REMARKS

In response to the Office Action mailed October 18, 2005, Applicants respectfully request reconsideration.

Serial No.: 10/679,996
Conf. No.: 4553

Fig 1A
Prior Art

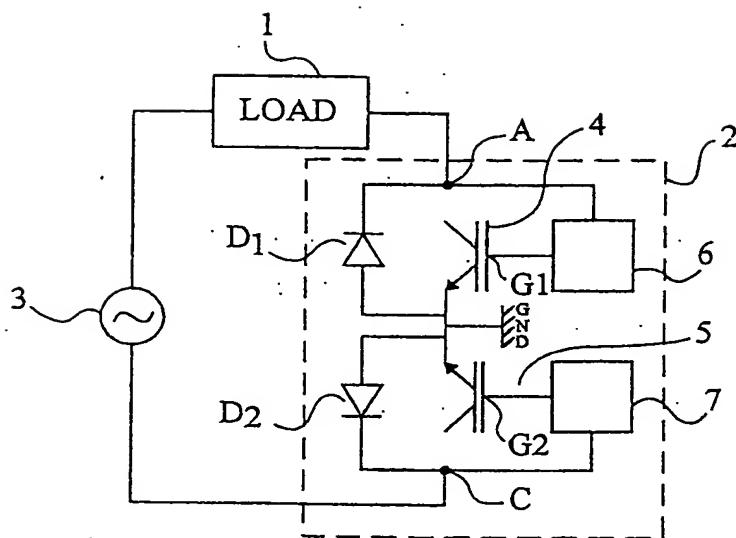
The Office Action noted that Figures 1A, 1B, and 2 should be designated by a legend such as -- Prior Art --. This has been done. Review and approval of the proposed drawing correction is respectfully requested.

“Replacement Sheet” is attached which includes a clean version of amended Figures 1A, 1B, and 2. The attached sheet replaces the original sheet including Figures 1A, 1B, and 2.
